UNITED STATES PATENT AND TRADEMARK OFFICE

APPLICATION NO.	FILING DATE	FIRST NAMED INVENTOR	ATTORNEY DOCKET NO.	CONFIRMATION NO.
09/462,502	01/24/2000	YASUO KONDO	10641-0001-3	5164
22850	7590	03/25/2004	EXAMINER	
OBLON, SPIVAK, MCCLELLAND, MAIER & NEUSTADT, P.C. 1940 DUKE STREET ALEXANDRIA, VA 22314			SIMONE, CATHERINE A	
		ART UNIT	PAPER NUMBER	
		1772

Office Action Summary	Application No.	Applicant(s)	
	09/462,502	KONDO ET AL.	
Examiner	Art Unit		
Catherine Simone	1772

DETAILED ACTION

FIG. I

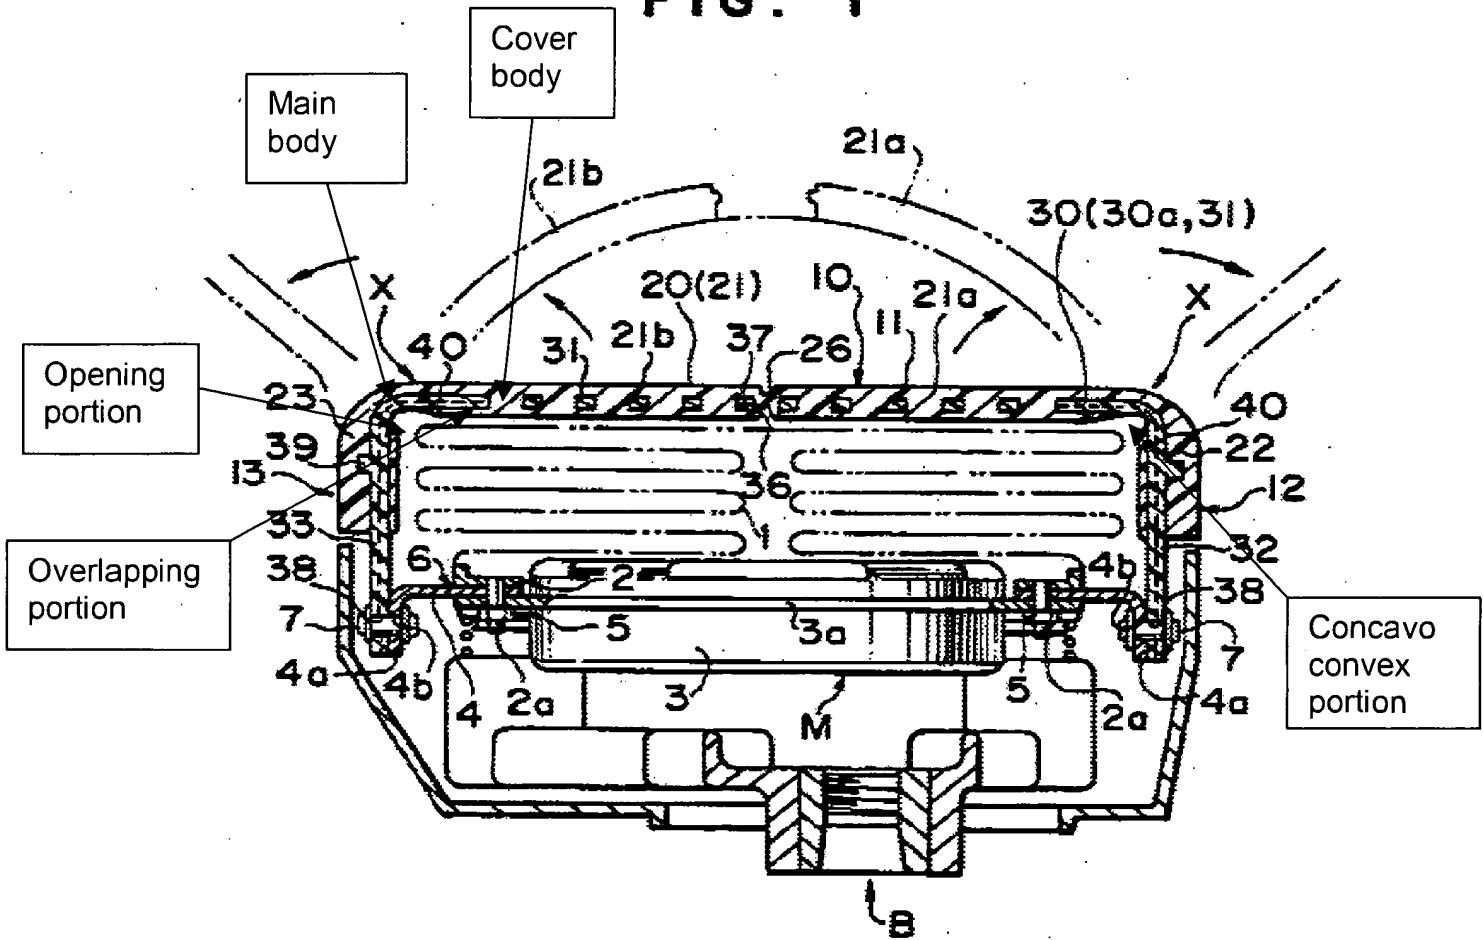
Regarding **claims 1, 12, 13 and 19**, Shiraki discloses a panel for an airbag of an automobile formed by integrally two-color molding a cover body (Figs. 1, 2 and 8, #20; also see col. 2, lines 58-59) made of a first synthetic resin with a main body (Figs. 1, 2 and 8, #30; also see col. 3, lines 3-6) made of a second synthetic resin which is harder than the first synthetic resin material (see col. 3, lines 5-6 and col. 4, lines 65-67), the panel comprising: a joint portion joined with the cover body (Figs. 1 and 8, #20) provided around an opening portion formed in the main body (see Fig. 1 below), wherein the joint portion constitutes an overlapping portion (see Fig. 1 below) in which an outer peripheral edge of the cover body overlaps and is provided on the inner side of an opening edge of the main body (Figs. 1 and 8, #30) and the overlapping portion is welded together in two-color molding in the main body with the cover body, further comprising a rib (Fig. 8, #33) projecting into the cover body on the rear face of a portion in which no first wall portion is formed; a connecting member (Fig. 8, #7) made of metal, extending from a side of the main body, and is connected to the rib; and a projection formed on a surface of the connecting member (Fig. 8, #7), the projection biting into a surface of the rib (Fig. 8, #33) when the connecting member is connected to the rib . Regarding **claim 3**, note, in Figure

1 shown below, a concavo-convex portion having a downwardly convex shape formed on a lower face of the main body (Fig. 1, #30). Regarding **claim 5**, note a surface of a periphery of the cover body (Fig. 1, #20) has a step portion (Fig. 1, #26) adjacent to the rear surface of the cover body and facing the edge of the opening portion of the main body, thereby, a groove portion (Fig. 1, #36) having a closed curve shape is formed in a boundary portion of an end portion of the opening portion of the main body (Fig. 1, #30) in the cover body (Fig. 1, #20), and a first wall portion which is thin and which ruptures (Fig. 1, #21) and a second wall portion which is at least 1.5 times as thick as the first wall portion and which does not rupture (Fig. 1, #31) at an operating time of the airbag are formed along the groove portion (Fig. 1, #36) in the cover body in a single line shape or a shape of plural continuous lines (see col. 3, lines 9-18). Regarding **claim 8**, note the second wall portion can be formed into a shape so as to have one transverse line on each of upper and lower sides of the cover body (Fig. 2), and the first wall portion is formed into a shape so as to have one longitudinal line on each of left-hand and right-hand sides of the cover body (Fig. 2); wherein a third wall portion (Fig. 2) which is thin and which is not formed along the groove portion is formed into a shape so as to have one transverse line in a central portion of the cover body; and wherein the first and third wall portions are formed into an H-shape (see col. 2, lines 58-68).

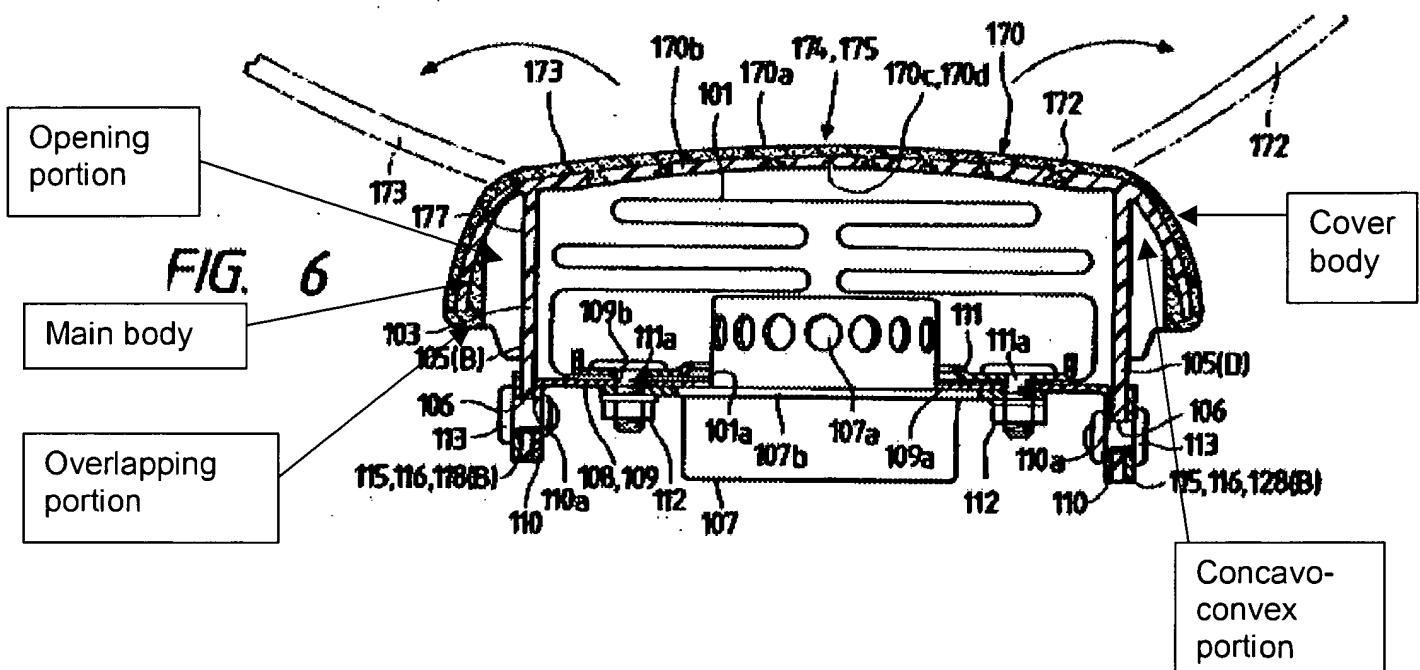
Regarding **claims 1, 12, 13 and 19**, Hiramitsu et al. discloses a panel for an airbag of an automobile formed by integrally two-color molding a cover body (Fig. 6, #170a) made of a first synthetic resin with a main body (Fig. 6, #170b) made of a second synthetic resin which is harder than the first synthetic resin material (see col. 8, lines 23-32), the panel comprising: a joint portion joined with the cover body (Fig. 6, #170a) provided around an opening portion formed in the main body (see Fig. 6 below), wherein the joint portion constitutes an overlapping portion

(see Fig. 6 below) in which an outer peripheral edge of the cover body overlaps and is provided on the inner side of an opening edge of the main body (Fig. 6, #170b) and the overlapping portion is welded together in two-color molding in the main body with the cover body, further comprising a rib (Fig. 6, #177) projecting into the cover body on the rear face of a portion in which no first wall portion is formed; a connecting member made of metal (Fig. 6, #113), extending from a side of the main body and is connected to the rib (Fig. 6, #177); and a projection formed on a surface of the connecting member (Fig. 6, #113), the projection biting into a surface of the rib (Fig. 6, #177) when the connecting member is connected to the rib.

Regarding **claim 3**, note, in Figure 1 shown below, a concavo-convex portion having a downwardly convex shape formed on a lower face of the main body (Fig. 6, #170b). Regarding **claim 5**, note a surface of a periphery of the cover body (Fig. 6, #170a) has a step portion adjacent to the rear surface of the cover body and facing the edge of the opening portion of the main body, thereby, a groove portion (Fig. 6, #170c) having a closed curve shape is formed in a boundary portion of an end portion of the opening portion of the main body (Fig. 6, #170b) in the cover body (Fig. 6, #170a), and a first wall portion which is thin and which ruptures and a second wall portion which is at least 1.5 times as thick as the first wall portion and which does not rupture at an operating time of the airbag are formed along the groove portion (Fig. 6, #170c) in the cover body in a single line shape or a shape of plural continuous lines (see col. 9, lines 53-68 and col. 8, lines 33-44). Regarding **claim 8**, note the second wall portion can be formed into a shape so as to have one transverse line on each of upper and lower sides of the cover body, and the first wall portion is formed into a shape so as to have one longitudinal line on each of left-hand and right-hand sides of the cover body; wherein a third wall portion which is thin and

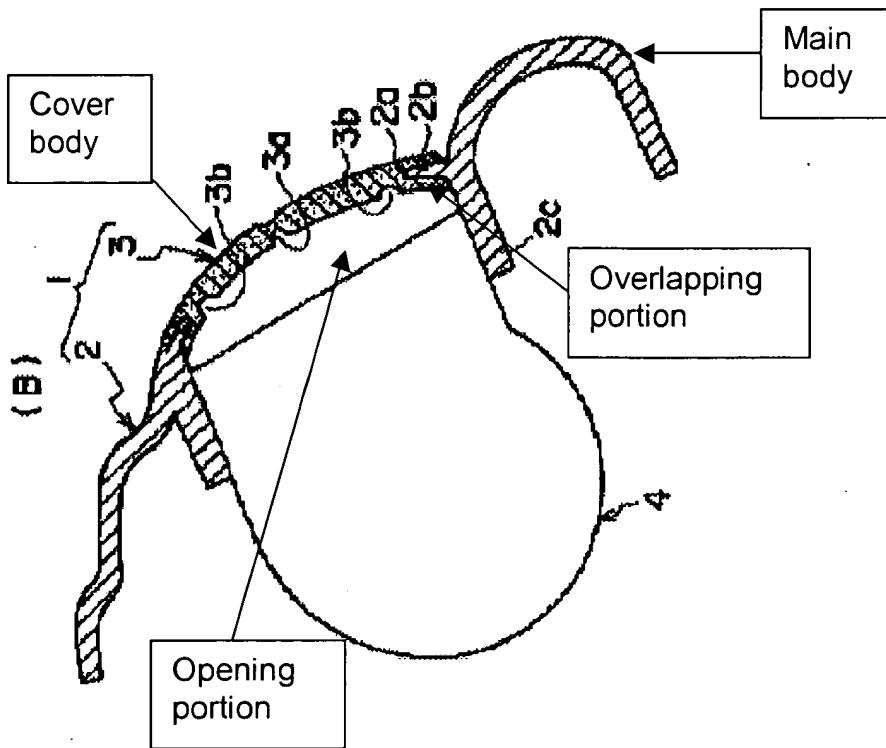
Regarding **claims 1 and 13**, Saito discloses a panel for an airbag of an automobile formed by integrally two-color molding a cover body (Drawing 1, element 3) made of a first synthetic resin with a main body (Drawing 1, element 2) made of a second synthetic resin which is harder than the first synthetic resin material (see page 2, paragraph 0011, lines 1-4 and page 4, paragraph 0036, lines 7), the panel comprising: a joint portion joined with the cover body (Drawing 1, element 3) provided around an opening portion formed in the main body (see Drawing 1 below), wherein the joint portion constitutes an overlapping portion (see Drawing 1 below) in which an outer peripheral edge of the cover body overlaps and is provided on the inner side of an opening edge of the main body (Drawing 1, element 2) and the overlapping portion is welded together in two-color molding in the main body with the cover body. Regarding **claim 5**, note a surface of a periphery of the cover body (Drawing 1, element 3) has a step portion adjacent to the rear surface of the cover body and facing the edge of the opening portion of the main body, thereby, a groove portion (Drawing 1, elements 3a and 3b) having a closed curve shape is formed in a boundary portion of an end portion of the opening portion of the main body (Drawing 1, element 2) in the cover body, and a first wall portion which is thin and which ruptures and a second wall portion which is at least 1.5 times as thick as the first wall portion and which does not rupture at an operating time of the airbag are formed along the groove portion

(Drawing 1, elements 3a and 3b) in the cover body in a single line shape or a shape of plural continuous lines (Drawing 1(a), elements 3a and 3b). Regarding **claim 8**, note the second wall portion can be formed into a shape so as to have one transverse line on each of upper and lower sides of the cover body (Drawing 1(a), element 3b), and the first wall portion is formed into a shape so as to have one longitudinal line on each of left-hand and right-hand sides of the cover body (drawing 1(a)); wherein a third wall portion which is thin and which is not formed along the groove portion is formed into a shape so as to have one transverse line (Drawing 1(a), element 3a) in a central portion of the cover body; and wherein the first and third wall portions are formed into an H-shape (see page 2, paragraph 0018).
